Attachment 007 Seeks to Answer Questions from Potential Bidders

Area	
Zone 1	VISIBLE GRID SYSTEM (NO TILE) IN THIS AREA
Zone 2	GWB CEILING ON METAL GRID
Zone 3	ZONE 3: VISIBLE CEILING TILE AND GRID, PLUS METAL HANGING SYSTEM (HIDDEN)
Zone 4	ZONE 4: VISIBLE CEILING GRID AND TILE PLUS UPPER LAYER OF 2 LAYERS OF CEILING BOARD WITH METAL GRID

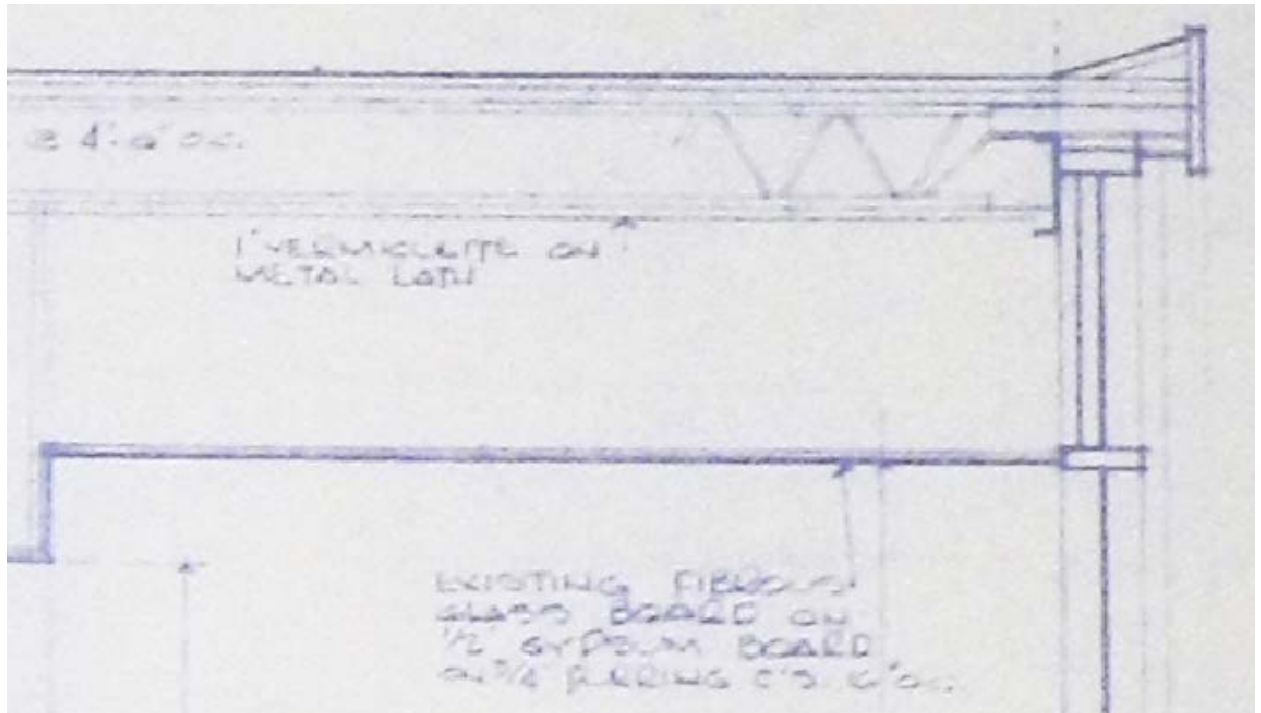
Q1. For us to price the demolition of that floor space we need to know how much of the ceiling space is one/two or three ceilings to remove and what the composition of the extra ceilings are. Some assumptions need to be made for pricing. Please advise what they are.

A1. Remove all Ceiling tile and ceiling grid below the level of the existing fireproofing vermiculite on metal at underside of structural beams
